IEC TC 80 WG 15 MTG29
Liaison note to ETSI TG26 and RTCM SC119
14-September-2018

Liaison note to ETSI TG26 and RTCM committee SC119

On the development of Man Overboard Devices (MOB)

Receiver Requirements for MSLD devices

Figure 1: Diagram showing stations likely to be involved in MOB situation

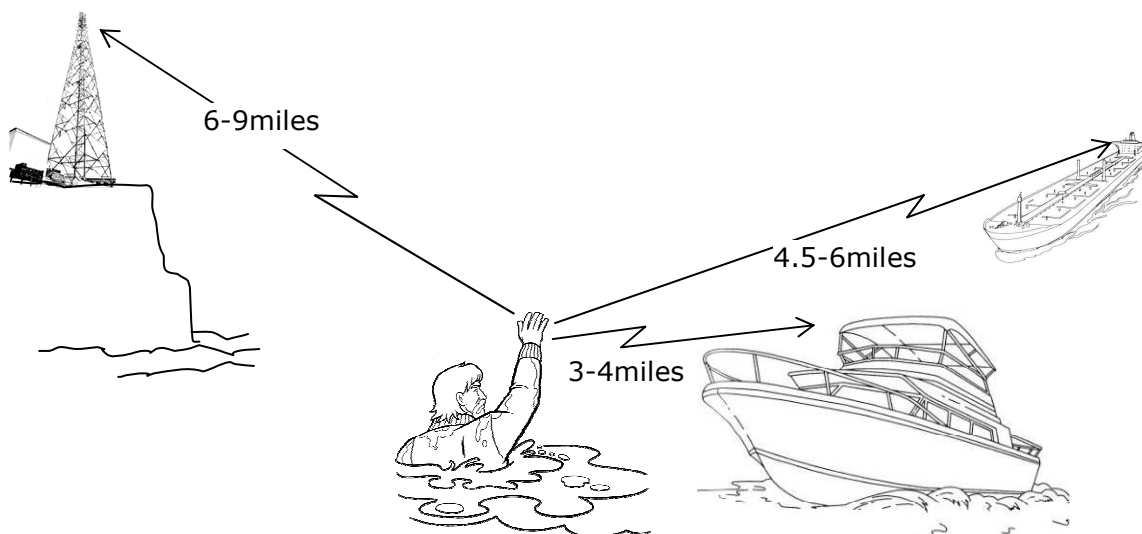
From Figure 1 above we can see that the range of a 500mW¹ MOB device on channel 70 will be limited. Unlike the 25Watt transmission of mobile

marine stations, the MOB has not only lower power, but significantly lower antenna height, which will significantly reduce the transmission range of the device.
